Access Compliance Report

Public Rights-of-Way

Intersection ID: 28355	Main Street: BRIDGE_CREEK_WY	Cross Street: BRIDGEHAMPTON CLUB DR	Location: NW
ADA ID: 4284A11AD83D	Ramp Type: Perp	Initial Pass/Fail: Fail	Overall Compliance: No
Severity Score: 21.25			
Codes/Mitigation Info/Possible Solution		Field Measurements/Component Compliance

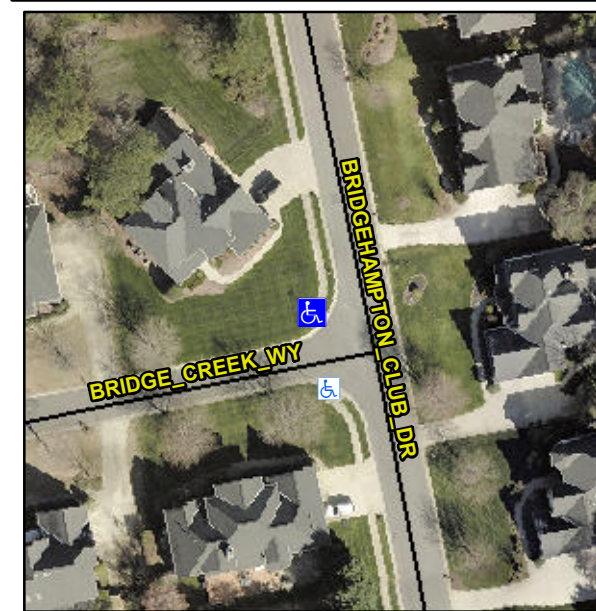
Not Found, R304.5.1, R304.2.2

Compliance	Description	Data	Compliance	Description	Data
N/A	Ramp Length (in)	47.5	No	Ramp Slope (%)	9.3
No	Ramp Width (in)	37.0	Yes	Ramp XSlope (%)	1.7
N/A	Flare Type LT	N/A	N/A	Flare Type RT	N/A
N/A	Flare Slope LT (%)	N/A	N/A	Flare Slope RT (%)	N/A
N/A	Flare Traversable LT?	N/A	N/A	Flare Traversable RT?	N/A
N/A	Landing Length (in)	N/A	N/A	DWS Provided?	N/A
N/A	Landing Width (in)	N/A	N/A	DWS Contrast?	N/A
N/A	Landing Slope (%)	N/A	N/A	DWS Length (in)	N/A
N/A	Landing X Slope (%)	N/A	N/A	DWS Full Width?	N/A
N/A	Landing Curb? (Y/N)	N/A	N/A	DWS Offset (in)	N/A
N/A	Shared Landing?	N/A			
N/A	Gutter Ponding?	N/A	N/A	Gutter Slope (%)	N/A
N/A	Gutter Lip Ht (in)	N/A	N/A	Gutter X Slope (%)	N/A
N/A	Painted X Walk1?	No	N/A	Painted X Walk2?	N/A
	X Walk 1 Direction	To S		X Walk 2 Direction	N/A
N/A	X Walk 1 Width (in)	N/A	N/A	X Walk 2 Width (in)	N/A
	X Walk 1 Slope (%)	6.7		X Walk 2 Slope (%)	N/A
	X Walk 1 X Slope (%)	4.4		X Walk 2 X Slope (%)	N/A

Remove & Replace Entire Ramp.
